E8362A-02A

**S E R V I C E N O T E**

E8362A PNA Microwave Network Analyzers

**Figure 1:** A3 Front Panel Interface Board Assy without the Bracket

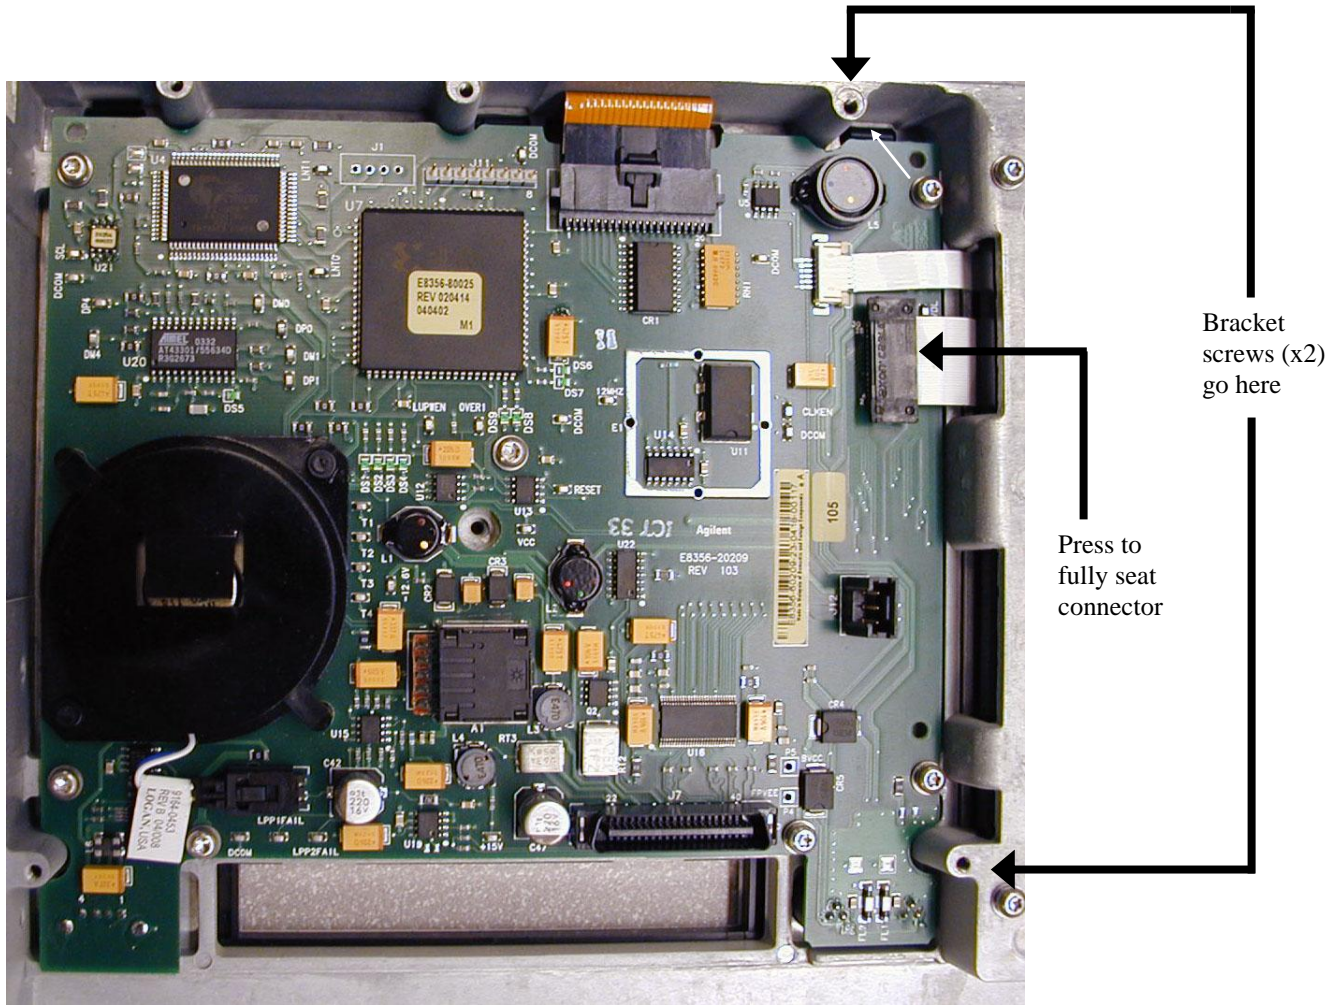
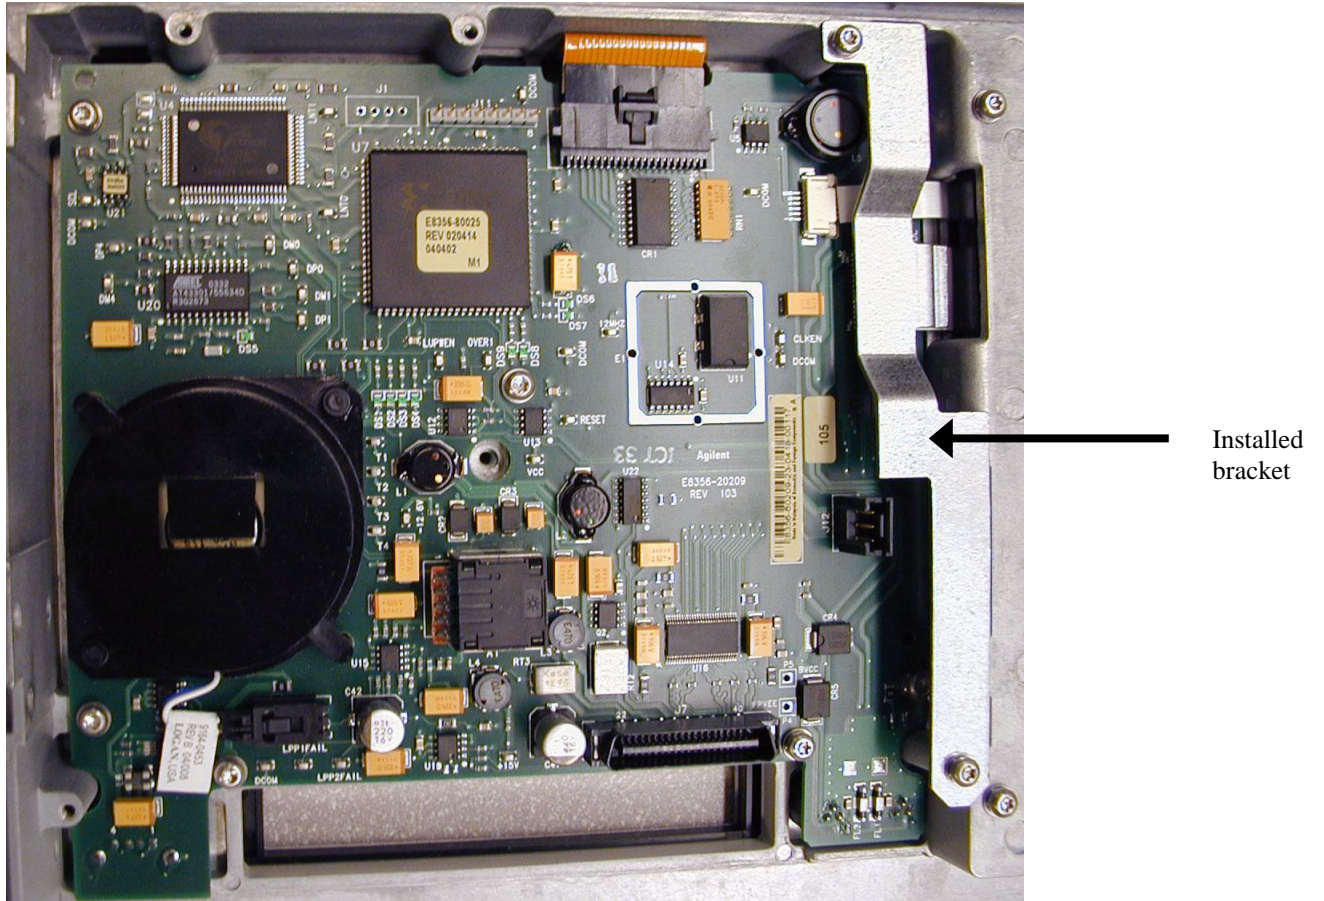
A connector of the ribbon cable (Agilent part number 8120-8409) that joins the front panel display to the front panel interface board can loosen, causing a display failure, unless a new bracket is installed. Because the failure rate has been very low, it is recommended that the bracket be installed only when there is an additional reason to remove the PNA front panel.

1. Refer to Figure 1 in this document:
  - Press down firmly on the ribbon cable's black connector.
  - Locate the two tapped holes for the bracket screws.
2. As shown in Figure 2 in this document, position the bracket so that its holes line-up with the two holes you located in the previous step.
3. Hand-start the two screws, and then torque both to 9 in-lbs.
4. Reinstall the PNA Front Panel by following the Service Guide instructions in the "Replacement Procedure." This is located on the same page as the "Removal Procedure" used previously in step 7.
